1500 Government Street

APPLICATION FOR PERMIT

Application No: P-2004-07

Date: April 20, 2004

LOCATION: 1500 Government Street

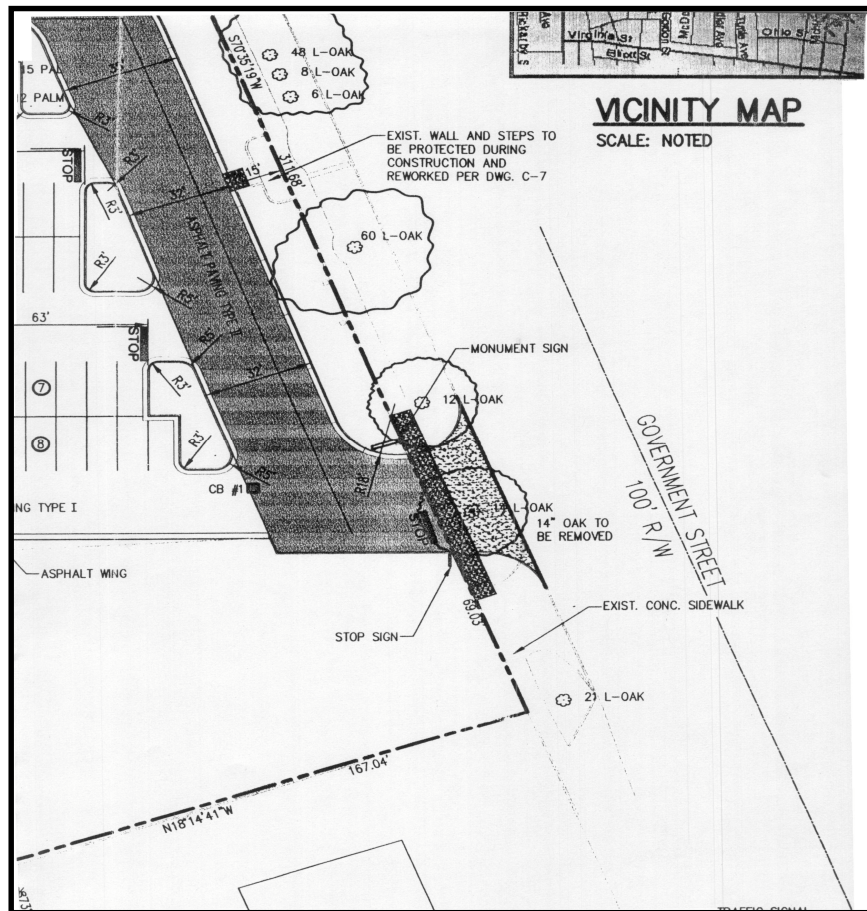
TREE HEALTH: Trees are in good condition.

SITUATION: Trees are being requested to be removed for ingress and egress of development.

STAFF RECOMMENDATION: Staff recommends removal of the 14" Live Oak with 2/1 replacement in inches (28"); driveway is to be shifted to the West to minimize impact on the Live Oak to the East of the existing driveway; existing driveway, curb and gutter is to be relocated and green space installed to the West of the new driveway; location to be coordinated with Urban Forestry, Traffic Engineering, Historical Preservation, and Planning; all work to be done with right of way permits.
